Annual Monitoring Report

Monitoring Year 5 of 7

Pee Dee Stream Restoration Project

RE: Pee Dee Stream Restoration Site: MY5 Monitoring Report (NCDMS ID 95350)

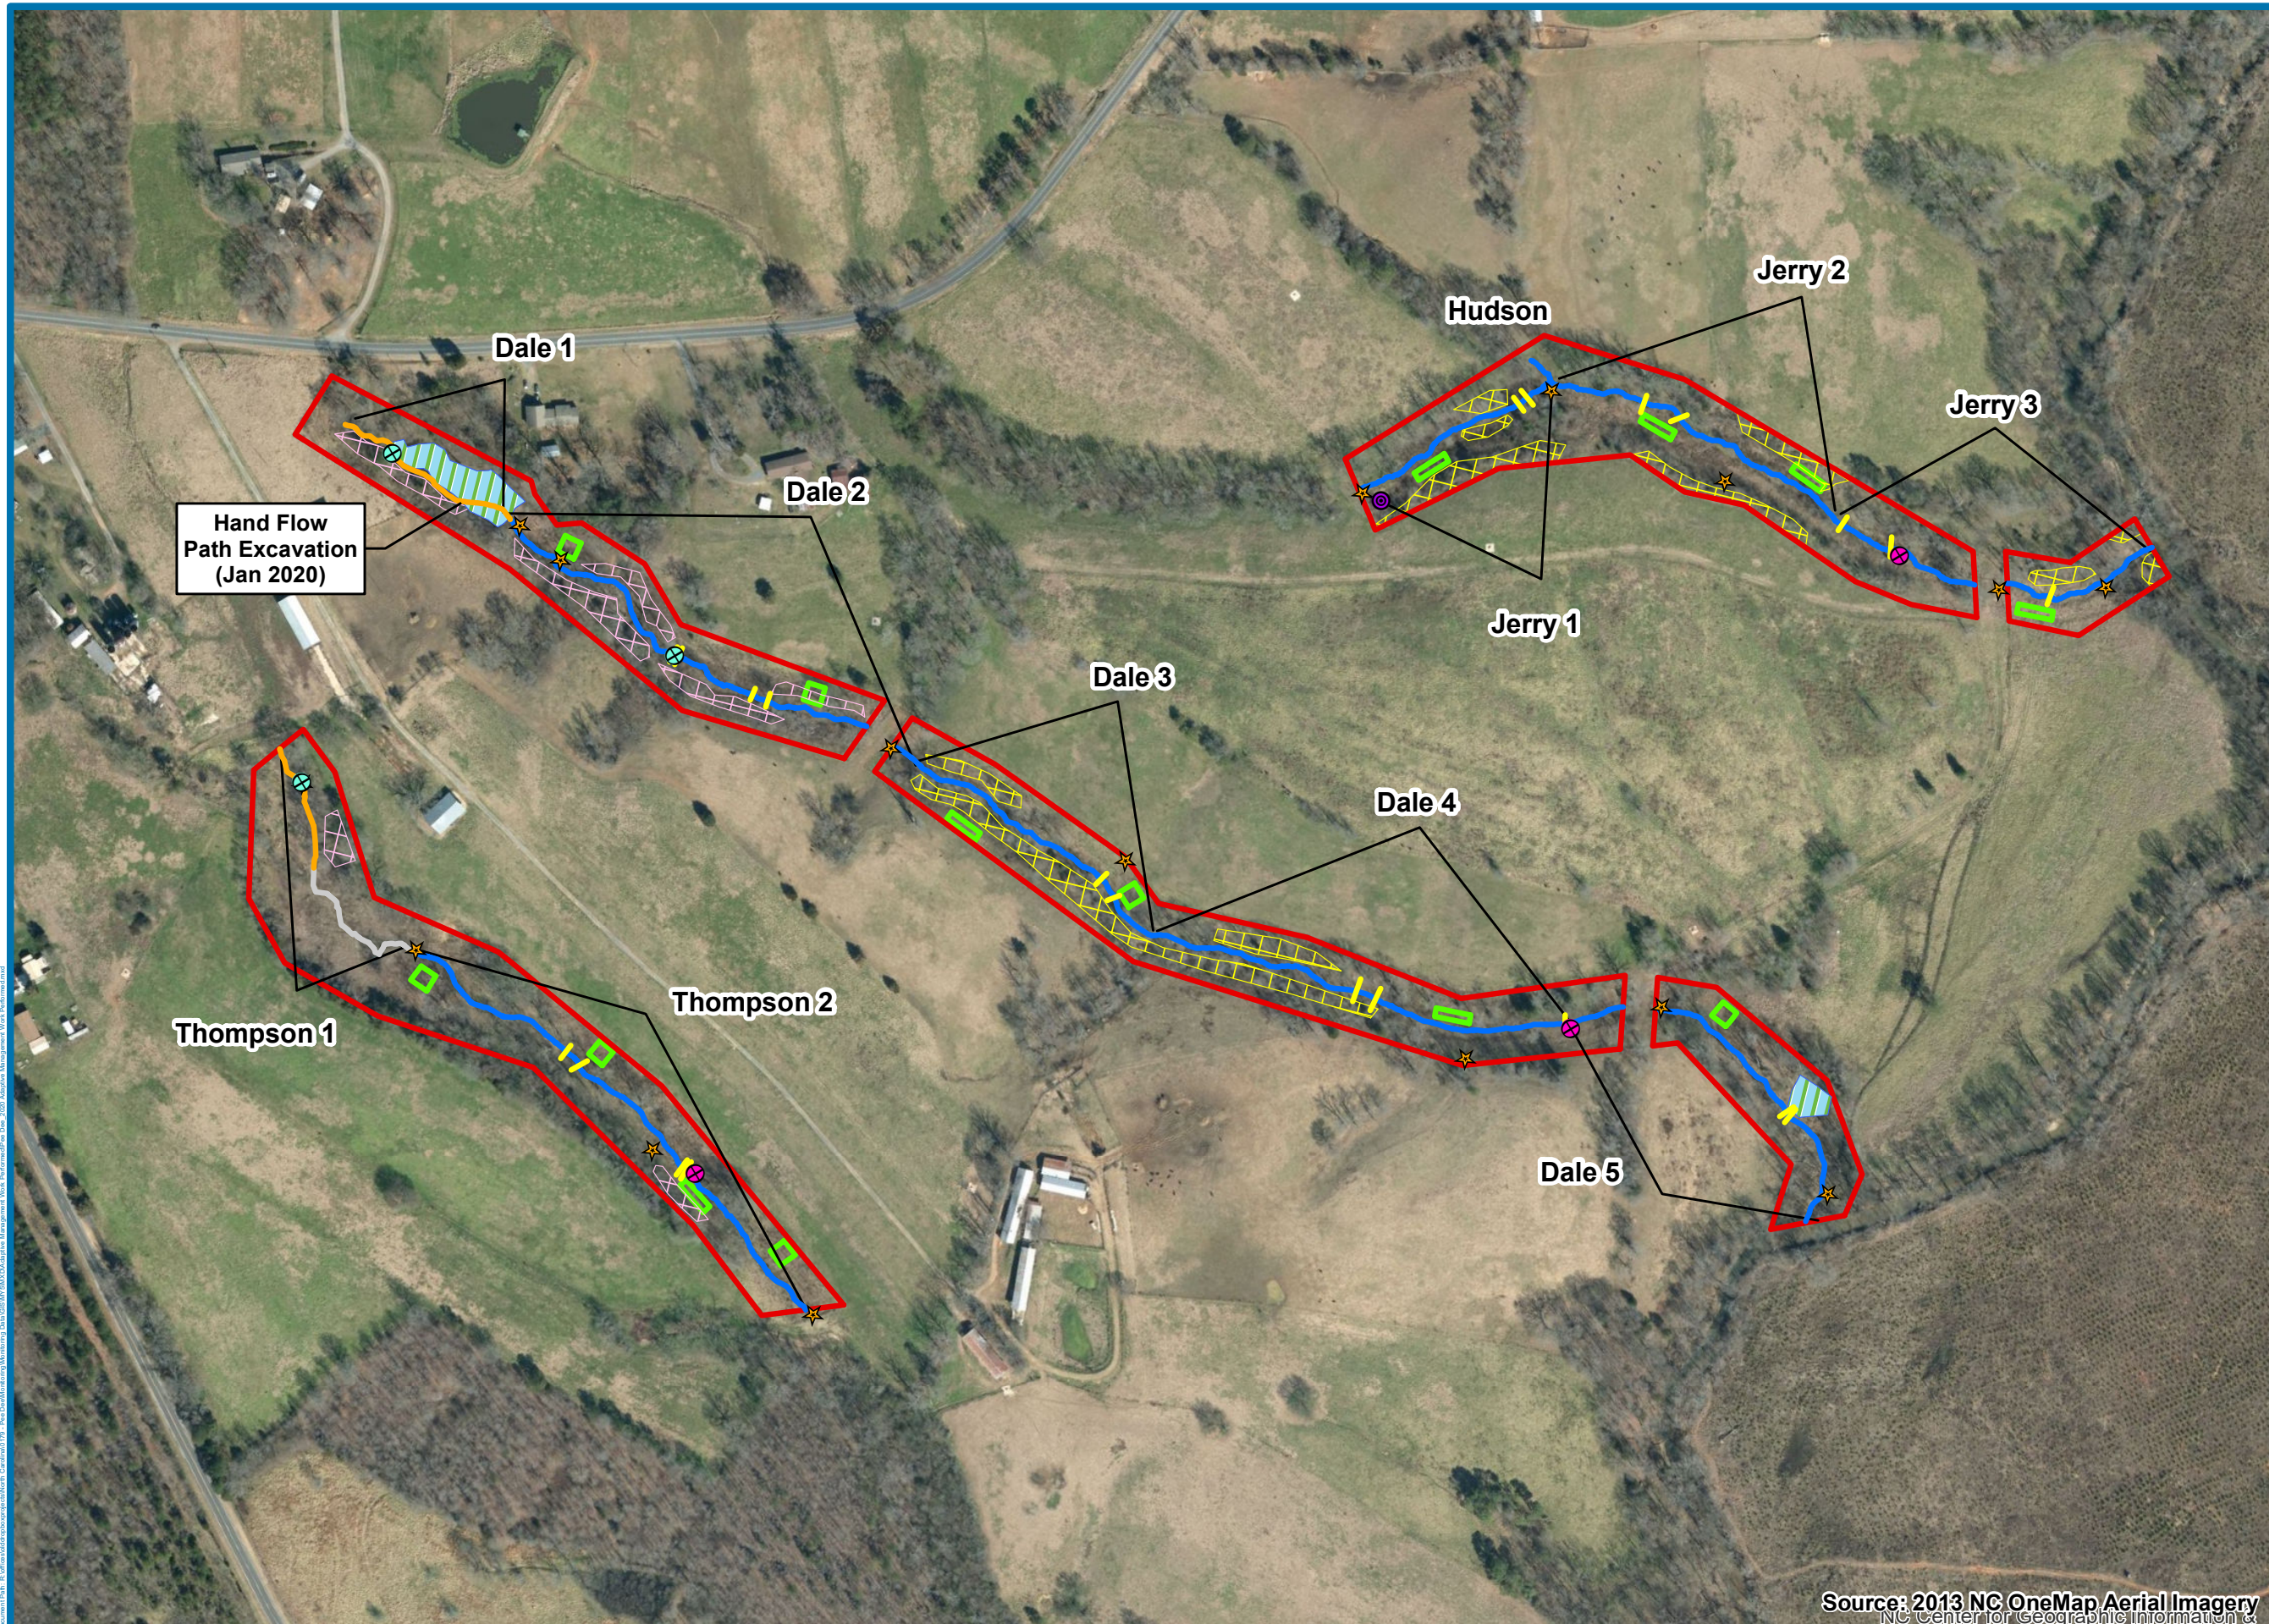
e) Memo from RES indicating any site Adaptive Management Work performed, when, and where, and how it followed (or varied from) the plan; include an 'as built' detail (zoomed in) map showing/describing the work as appropriate, with any new monitoring features. Any new monitoring features should also be shown on the CCPVs.

[These items have been added to Appendix F.](#)
